ADDENDUM NO: 1

PROJECT: **SITE IMPROVEMENTS AT FRANKLIN CENTRAL JUNIOR HIGH**

CONTEXT PROJECT NO: 22-1613 DATE: 2/13/2024 BY: Fred Prazeau

1
PRINT DATE: 2/13/24
PLOT SCALE: 1:1 | EDIT DATE: 2/13/24 - 11:00 AM | EDITED BY: NBALENTINE | DRAWING FILE: Z:\PROJECTS\2023\0154 - FRANKLIN CENTRAL JR HIGH\2 DESIGN\CAD\C420 UTILITY PROFILES PLAN TENNIS PAVED LOT.DWG

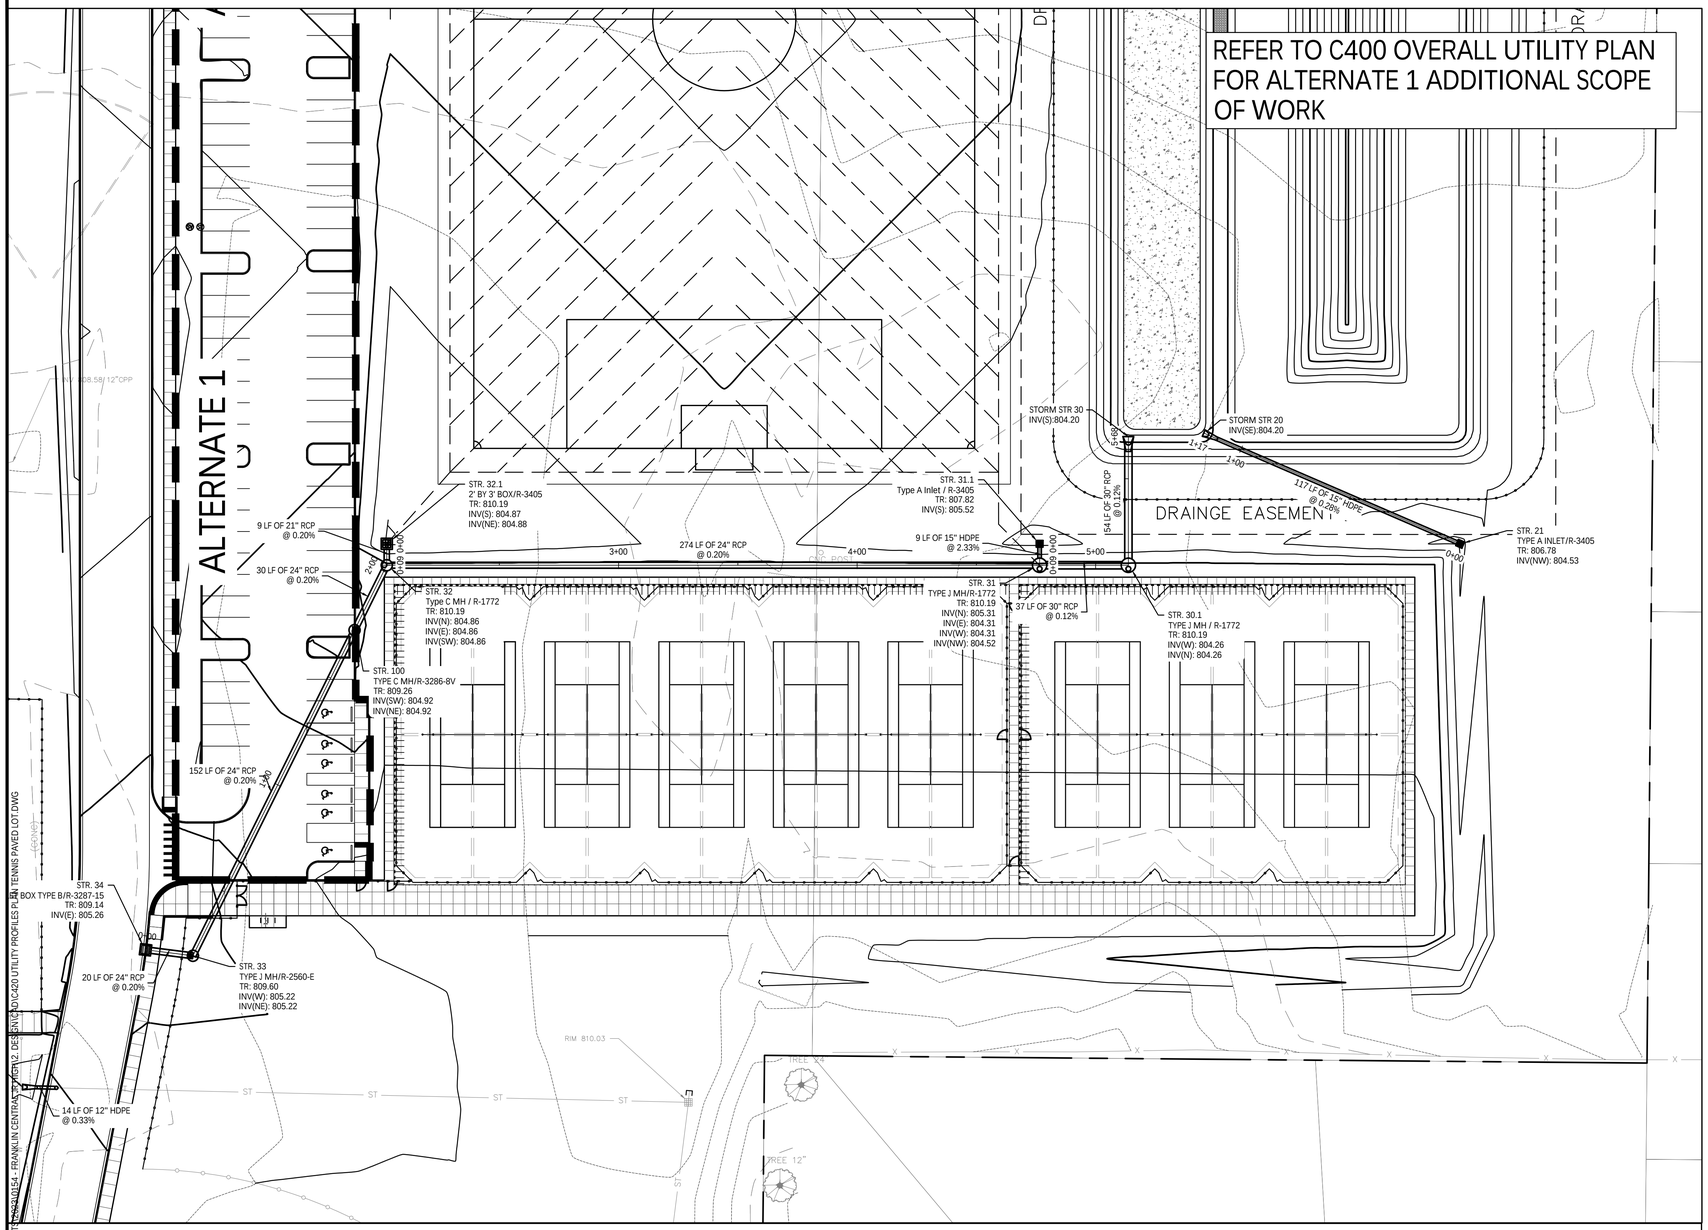
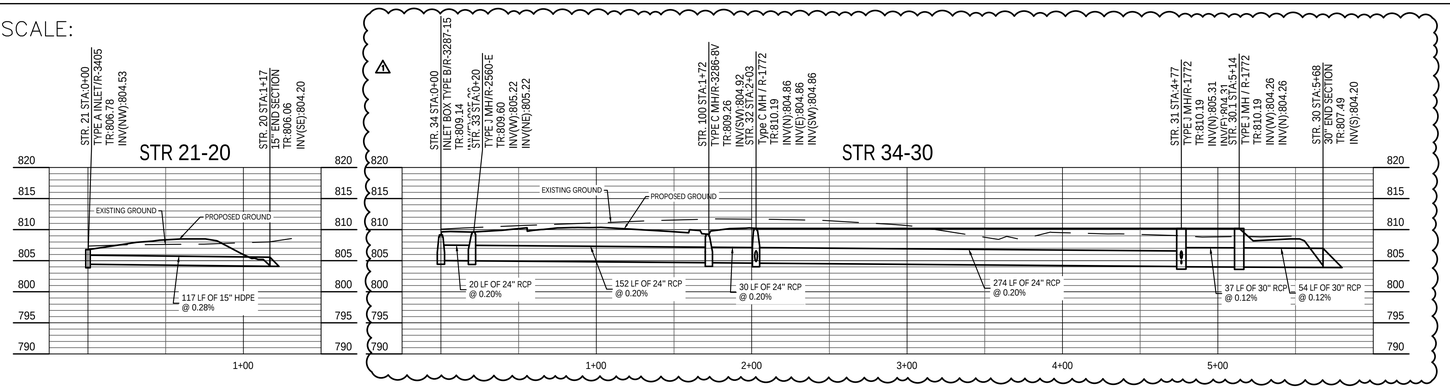
4. C420-Series Utility Profile Plans reissued to address City comments, including clarification to storm structures to reflect grading revisions and sufficient cover, subsurface drainage as indicated on plans, and storm structure network for Alternate #1 – Soccer Parking. [Note that Sheets C426 & C427 are newly-added]

Sheet No:
C502

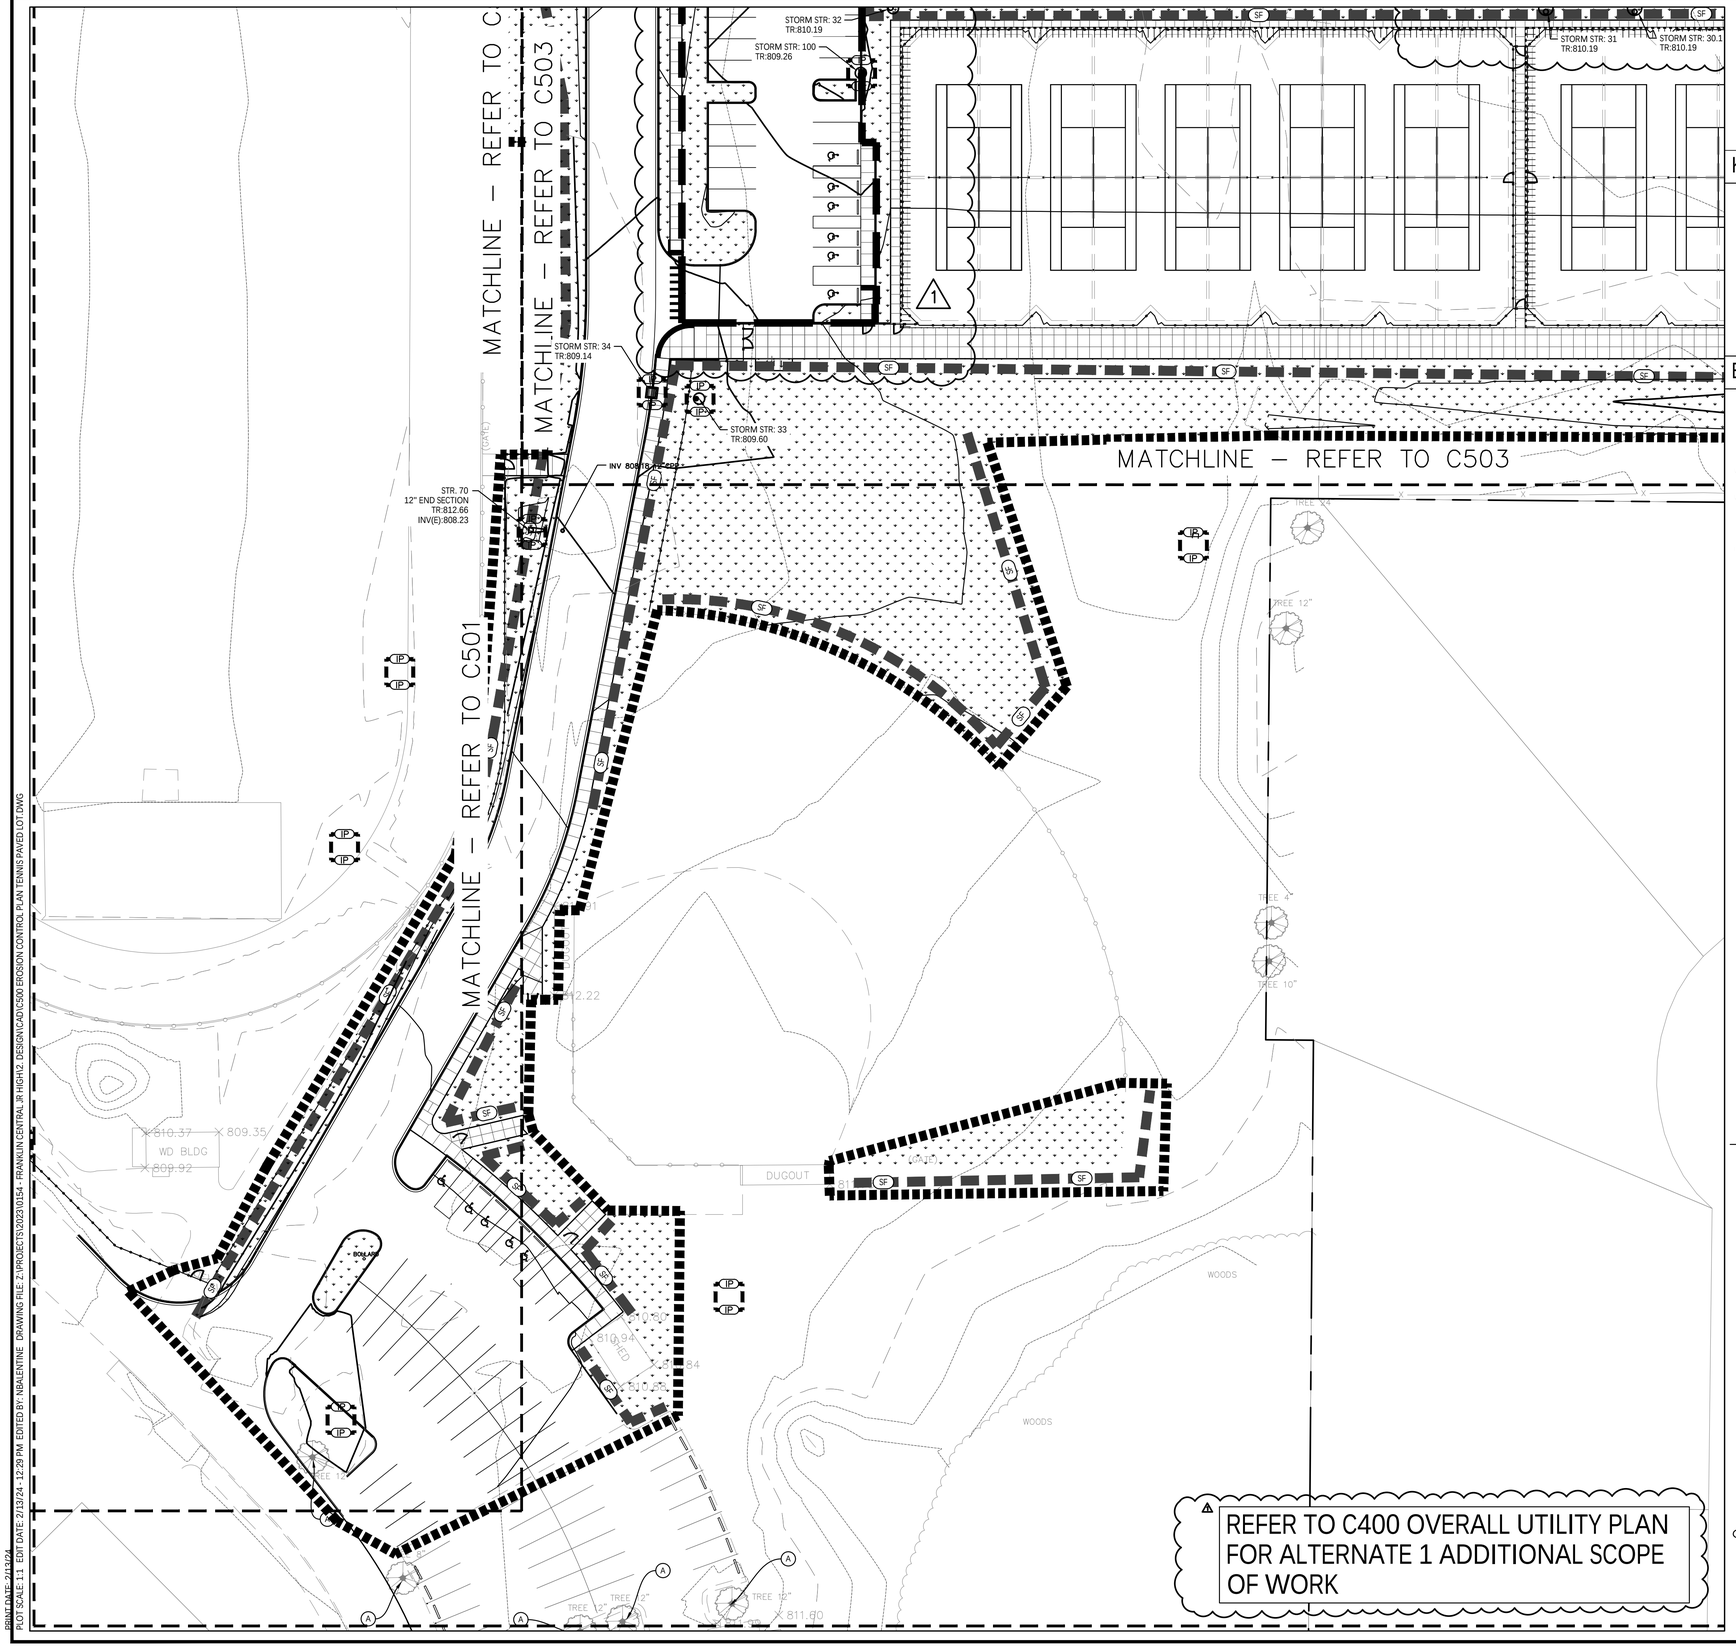
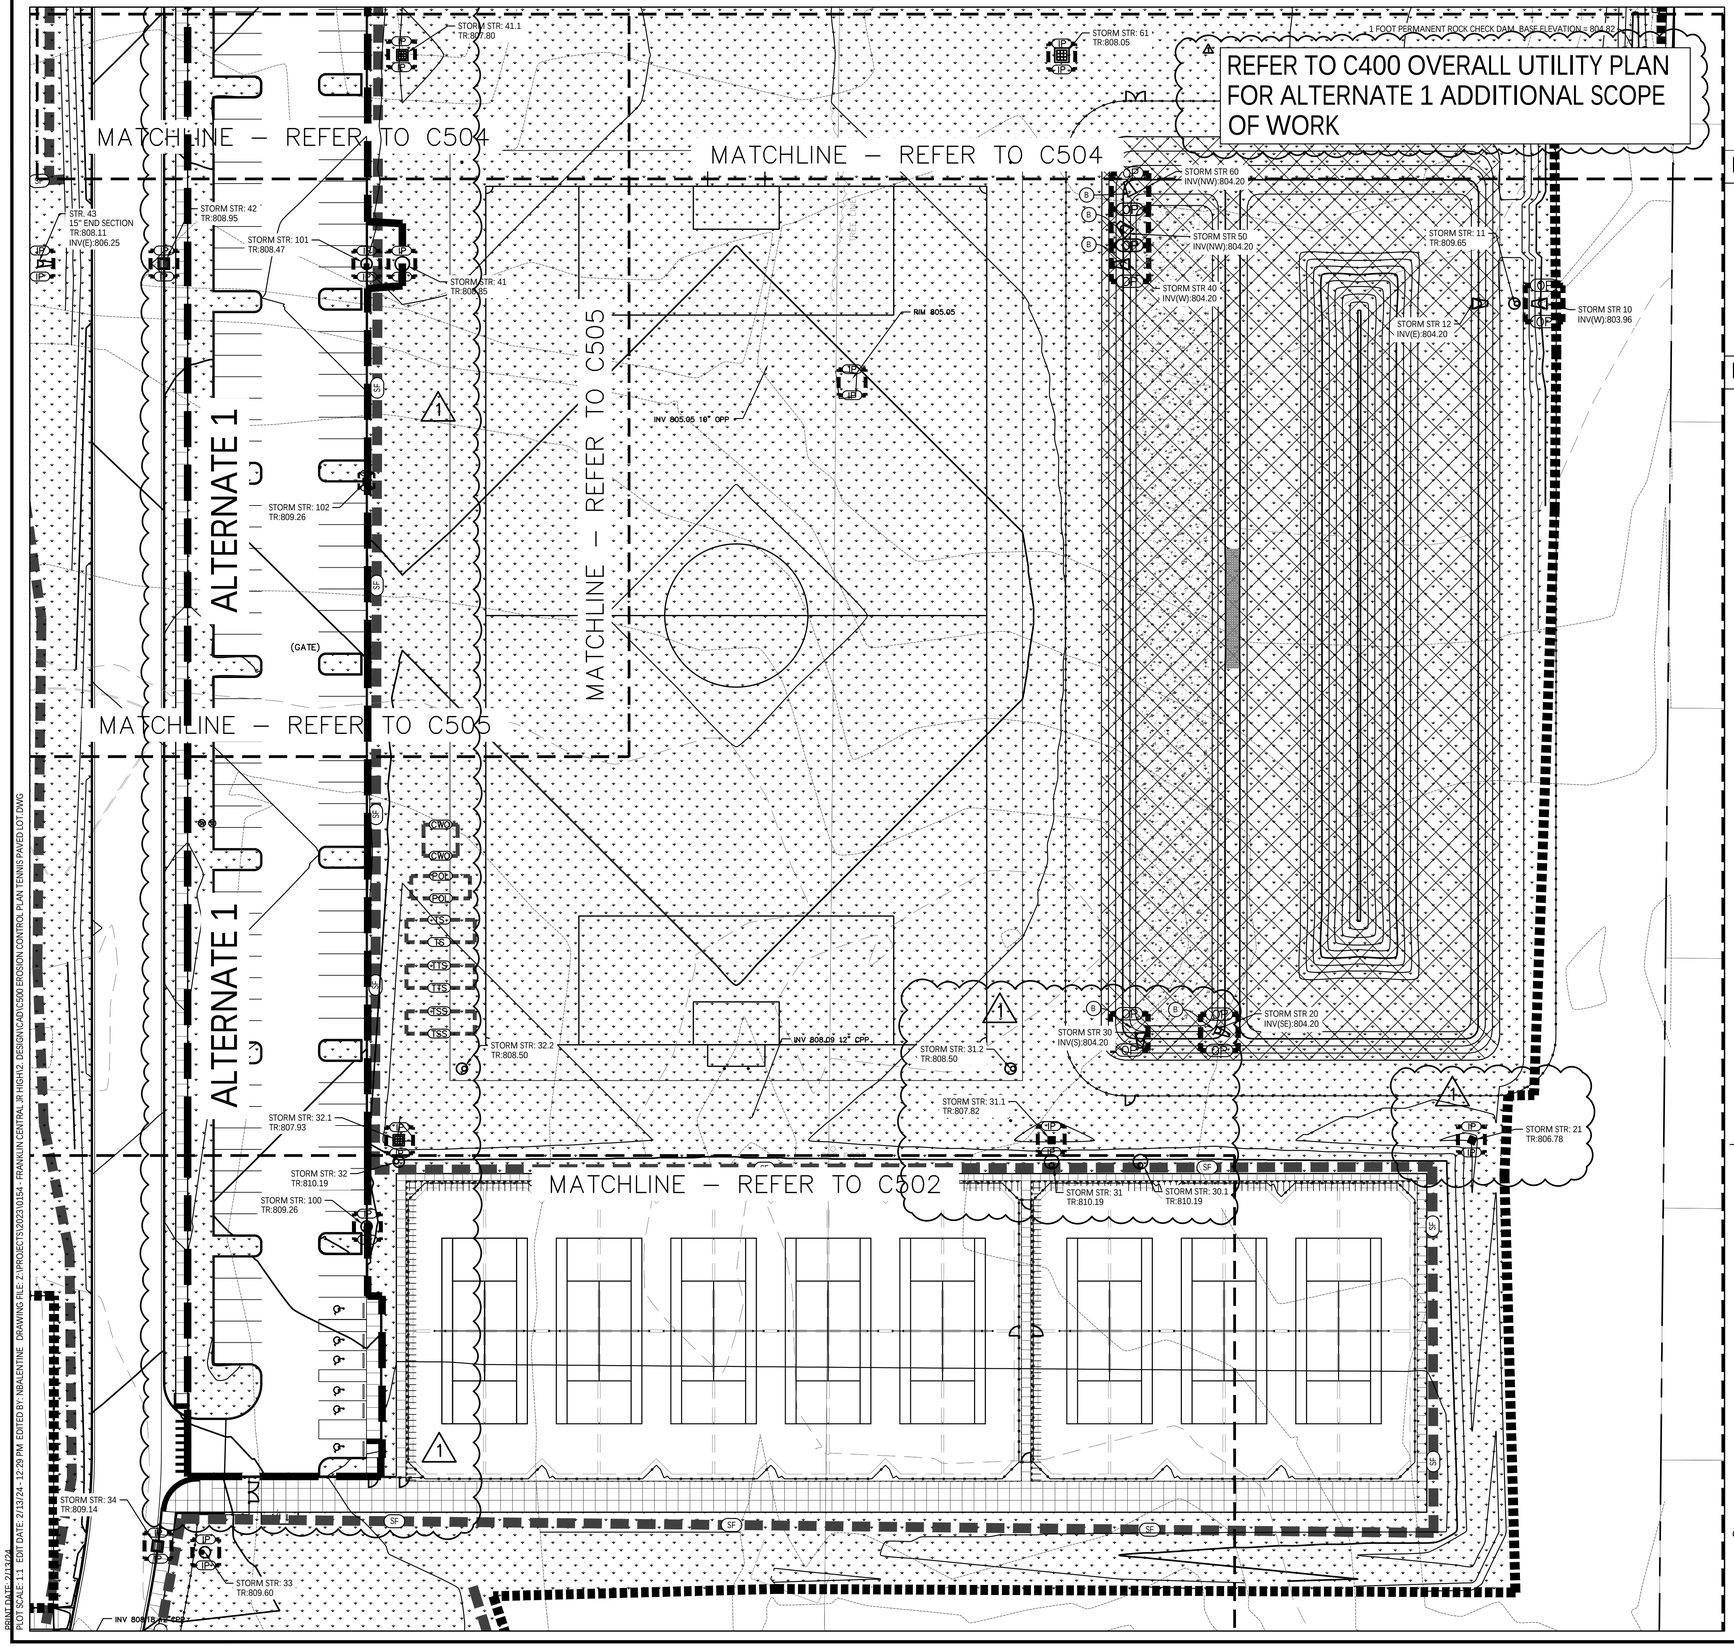
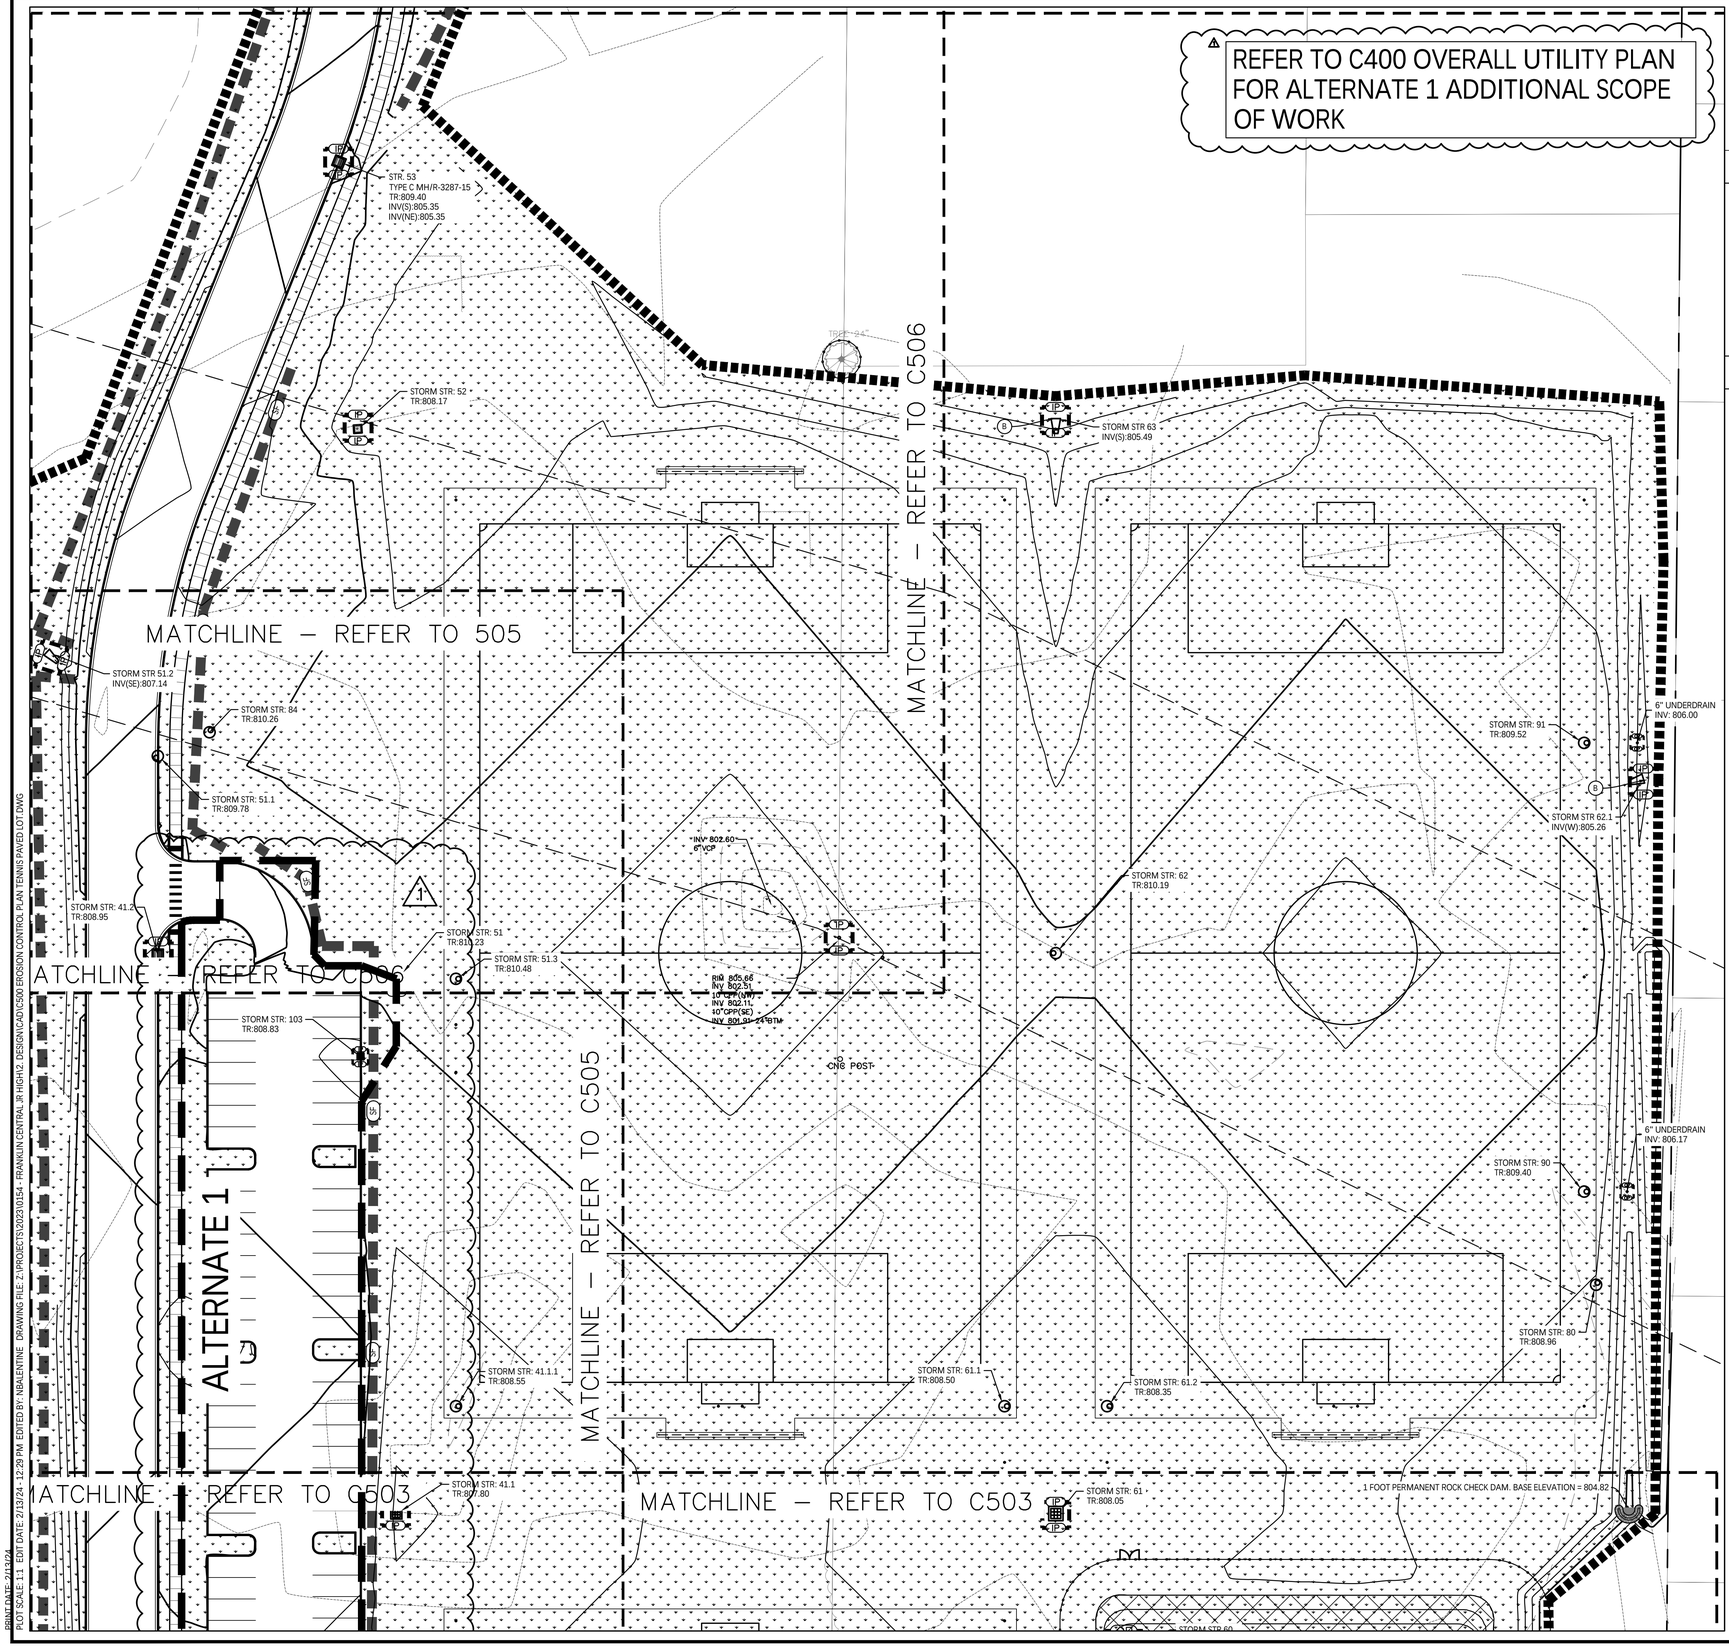
5. C430-Series Regulated Drain Replacement Plans reissued to match Alternates listed on Bid Form.
6. C500-Series Erosion Control Plans reissued to address City comments, including clarification in the vicinity of the Alternate #1 – Soccer Parking lot.
